REQUEST

Current Zoning: R-3 (single family residential)
Proposed Zoning: INST(CD) (institutional, conditional)

Approximately 5.24 acres located at the northwest intersection of Mallard Creek Road and Hubbard Road, south of West W.T. Harris Boulevard, and east of West Sugar Creek Road.

The petition proposes a residential independent living facility with up to 107 units in one building with a density of 20.4 dwelling units per acre.

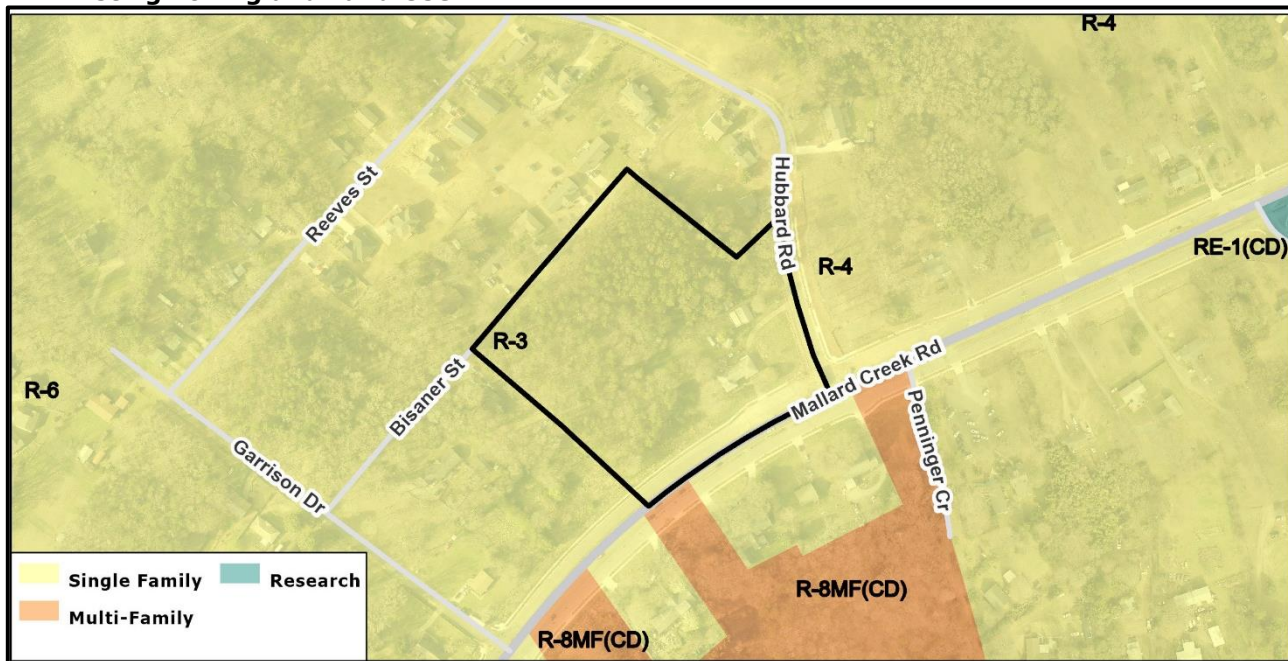
• **Proposed Request Details**

The site plan accompanying this petition contains the following provisions:

- Allows 107 age-restricted units in one building.
- Limits building height to 60-feet.
- Provides an ADA compliant bus pad on Mallard Creek Road.
- Commits to an eight-foot planting strip and a 12-foot multi-use path alongside Mallard Creek Road, and an 8-foot sidewalk and an 8-foot planting strip alongside Hubbard Road.

- Access is provided by a driveway on Hubbard Street and Mallard Creek Road as right-in/right-out.
- Provides a minimum 3,500 of improved open space with walking paths, landscaping, and seating area.

- Provides a 32-foot Class C buffer along the property boundaries that abut single family zoning or use.
- Architectural Details:
 - Building materials will be a combination of portions of some of the following: brick, stone, precast stone, precast concrete, synthetic stone, cementitious fiber board, stucco, EIFS, decorative block and/or wood.
